Service Bulletin

S.B. No: 172

Title: INSPECTION OF FLAP DRIVE TORQUE TUBE

FIGURE 1

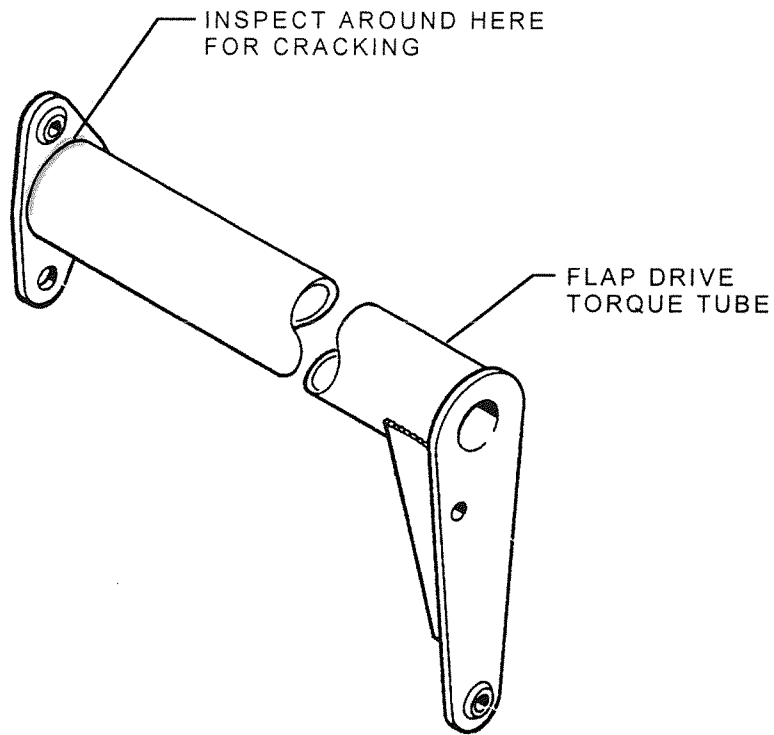
A case has been reported of a crack on the flap drive torque tube, pivot to tube brazed joint located at the inboard end of the torque tube.

1. Gain access to the inboard end of the flap drive torque tube.
2. Visually inspect for signs of cracking, i.e. flaked paint etc. in area indicated ref. Figure 1. If in doubt remove paint locally and use dye penetrant as required.
3. If no cracks are present, annotate logbook "SB172 complied with". Note if paint removed, clean and repaint.
4. If cracking is present, obtain new welded item T67G-45-243/244 from Slingsby Aviation Limited. Annotate logbook "SB 172 complied with, Mod M948 invoked".
